P 521613

ON-SITE SEWAGE DISPOSAL SYSTEM
HOWARD COUNTY HEALTH DEPARTMENT
BUREAU OF ENVIRONMENTAL HEALTH
3525-H ELLICOTT MILLS DRIVE, ELLICOTT CITY, MD 21043

SUBDIVISION: Holly Hills 15

ADDRESS: ³³²⁶~~3226~~ Sang Road PROPERTY OWNER: Patuxent Builders, Inc.

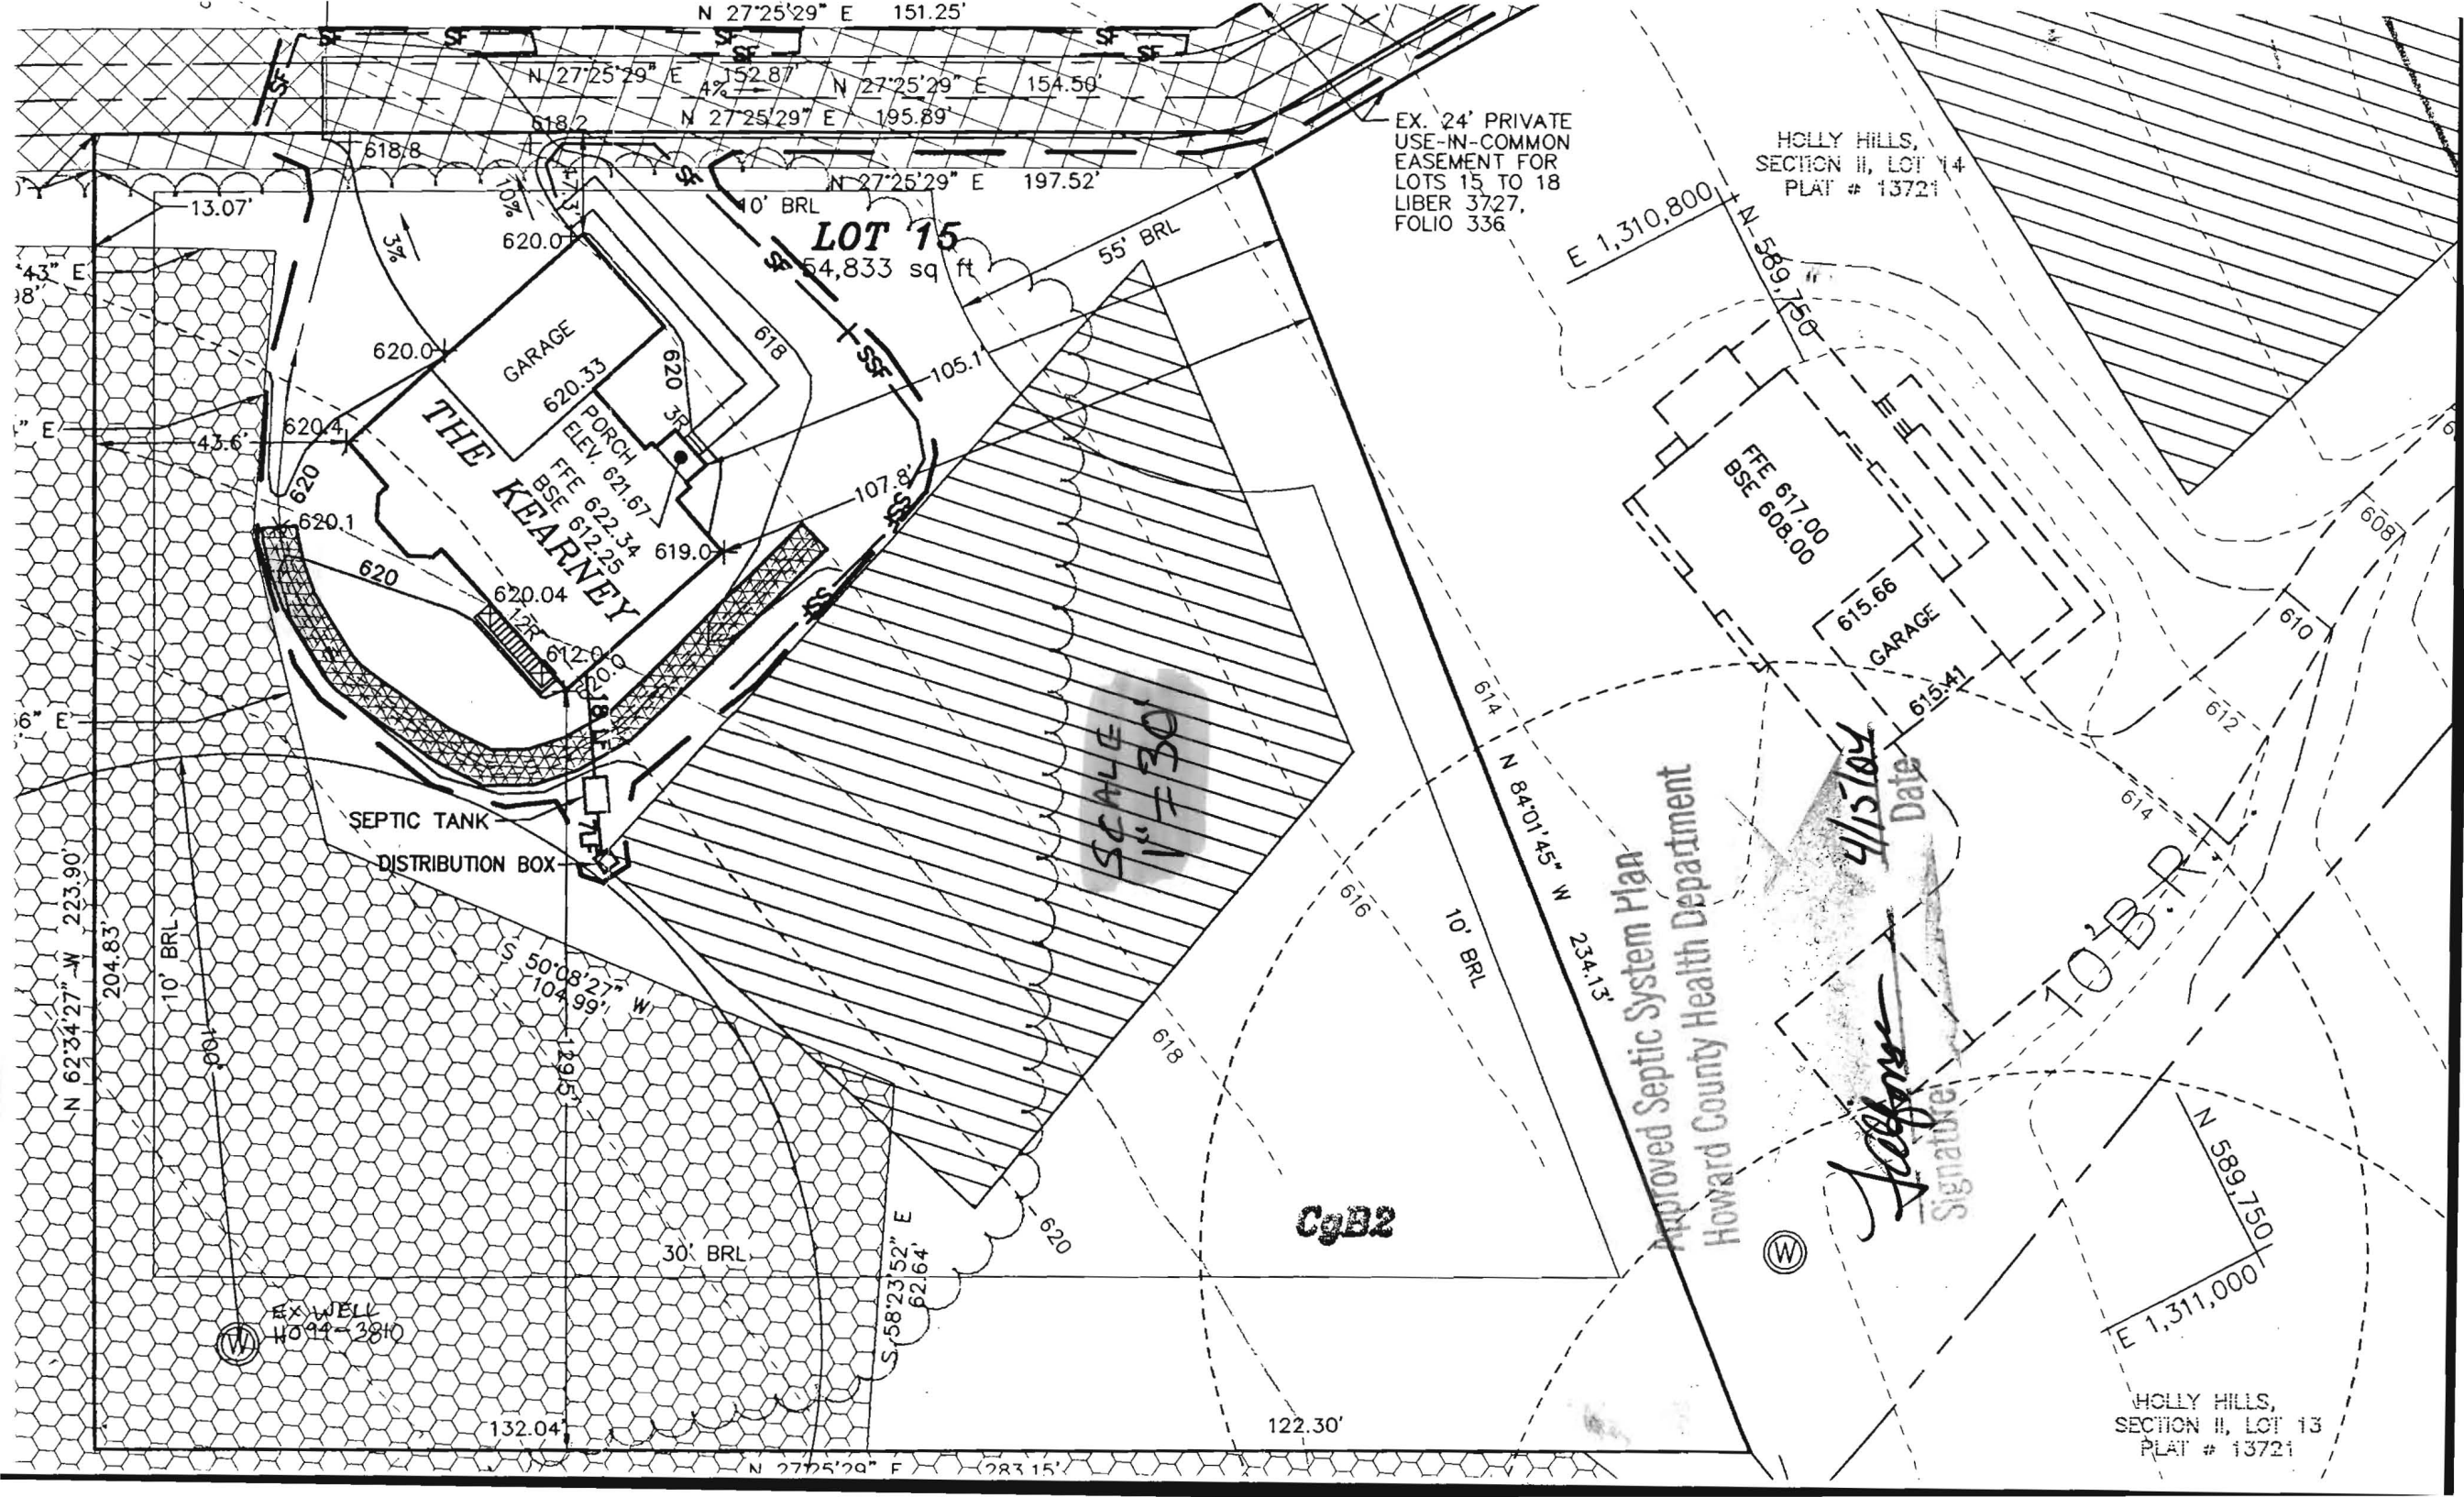
PRE-CONSTRUCTION 12/20/04 Tank set. Install 2 - 100' trenches at the top of the septic easement. Work around trees as best possible to conserve area. (BB)

INSTALLATION 12/21/04 Trenches dug to avoid trees. O.K. to cover everything. (BB)
